Dart Aerospace Ltd. Thursday, 7/12/2007 10:39:33 AM Kim Johnston **Process Sheet** : DOOR DOUBLER : CU-DAR001 Dart Helicopters Services **Drawing Name** Customer Job Number : 33524 12942 **Estimate Number** : D3594044 **Part Number** P.O. Number A/4: .01.0.2 D3594 REV A 7/12/2007 **Drawing Number** This Issue : N/A Project Number Prsht Rev. : SMALL /MED FAB **Drawing Revision** First Issue Type Material Previous Run : 7/17/2007 Each Qty: 4 Um: **Due Date** Written By Checked & Approved By New Issue 07-01-22 EC Comment **Additional Product** Job Number: Description: Seq. #: 6061-T6 .080 Sheet M6061T6S080 1.0 Comment: Qtv.: Total: 2.1420 sf(s) 0.5355 sf(s)/Unit 6061-T6 .080 Sheet Batch: W 2.0 WATER JE Comment: FLOW WATER JET 1-Cut as per Dwg D3594 Dwg Rev: A Prog Rev: ___________ 2-Deburr if necessary 3.0 QC2 ES Comment: INSPECT PARTS AS THEY COME OFF MACHINE 4.0 SECOND CHECK QC8 Comment: SECOND CHECK SMALL & MEDIUM FAB RESOURCE 1 SMALL FAB 1 5.0

NCR:3	3524	f w	ORK OR	DER NON-CONFORMANC	E (NCR)	C)	 .
DATE	STEP	Description of NC . Section A	Initial Chiev Eng	Corrective Action Section B Action Description Chief Eng	Sign &	Verification Section C	Approval Chief Eng	Approval QC Inspecto

D3594-3 FLOOR DOUBLER (D3594-4 OPPOSITE)

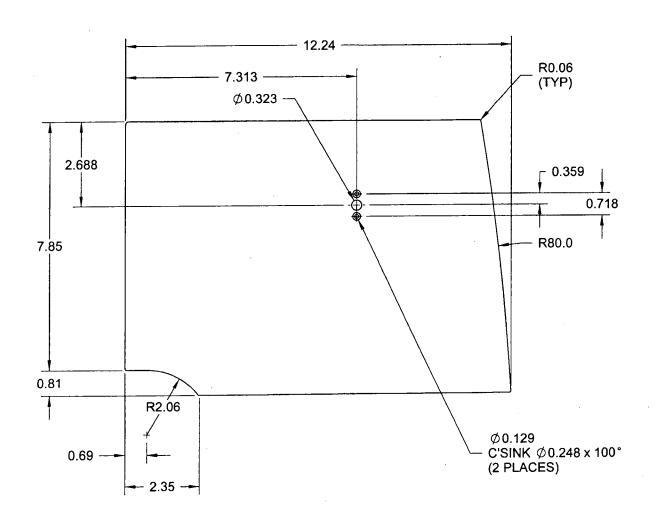
Good afternoon. I had 4x D3594-043 doublers B33523, and 4x D3594-044 doublers B33524, that needed to be re-worked. For the -044, 2 parts were incorrectly counter sunk, resulting in the hole being slightly over sized. For the -043, 1 part was counter sunk too deep, which would have resulted in a bad assembly, meaning in correct riveting (a tiny gap between the material, and the rivet head). I had the parts re-worked by filling the holes necessary with weld, seeing as how the material was 6061-T6, and ground flush to the surface, then transfer drilled too the drawing. The hole sizes were only 0.129". Is this acceptable to you?

As these parts are for the D412-698-023 Door Opener Kit and the rivet holes are used to install a nutplate, the rework you have outlined below is acceptable to me.
